Fakir Fashion Ltd. (Extension - 3)

5 February 2024

2. Observations

Observation-3: Crack on brick wall at ground floor (Building-8 -New ETP).

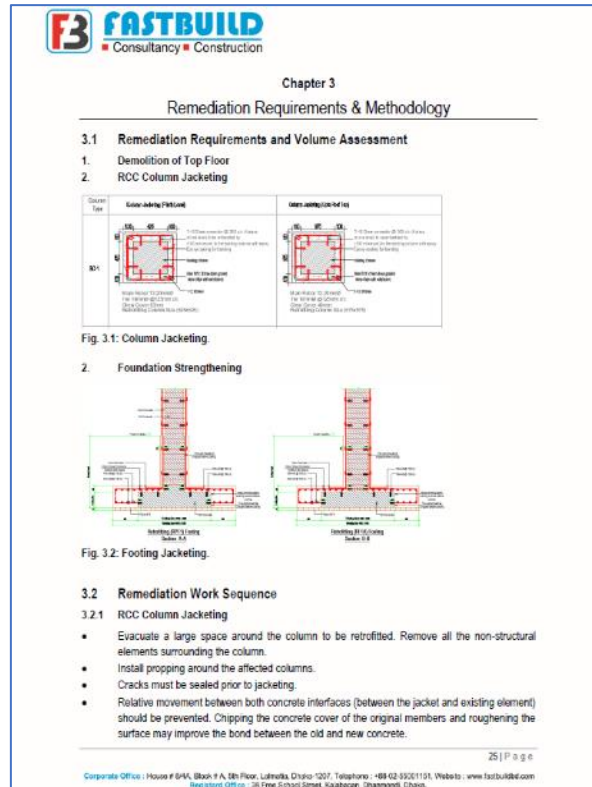
Description: Crack was found on brick wall at ground floor. The building engineer is required to investigate the reason of crack and repair as per investigation report.

Observation-5: Required retrofitting work required to be carried out as per DEA after reviewed by RSC (Building-12).

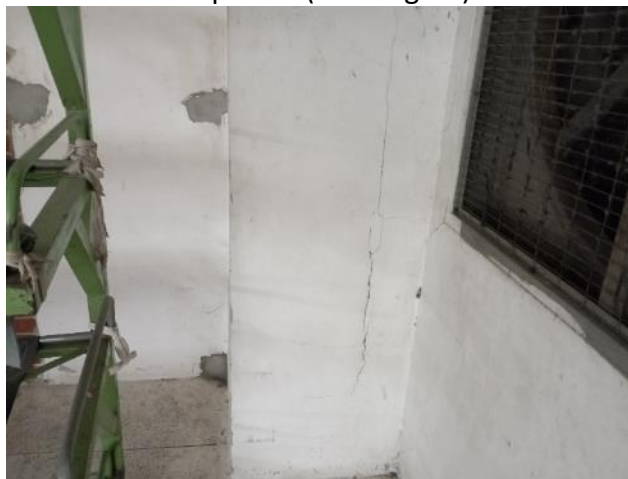
Description: As per the prepared DEA some footings and columns are required to be strengthened. All kinds of retrofitting work are required to be carried out as per DEA after reviewed by RSC. Submit DEA document to the RSC for review.

Observation-06: Crack on brick wall at top floor (Building-12).

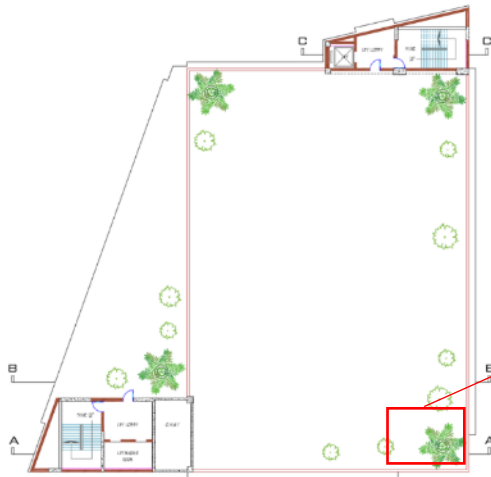
Description: Crack was found on brick wall at top floor. The building engineer is required to investigate the cracked area and repair with a suitable method.

Observation-09: Water clogging and lack of drainage system on roof. (Building 16)

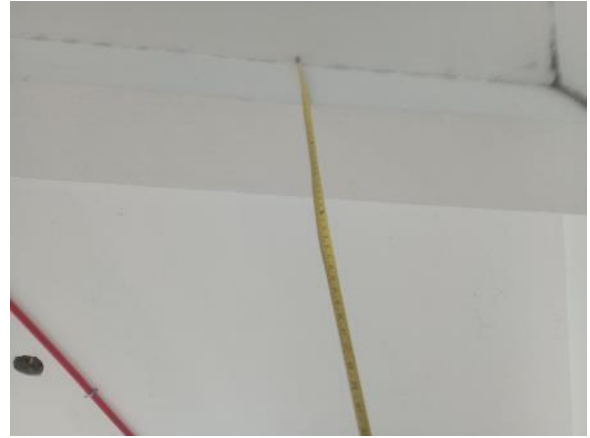
Description: During inspection, water ponding was observed on the roof. The building engineer is required to improve adequate slope for drainage purpose.
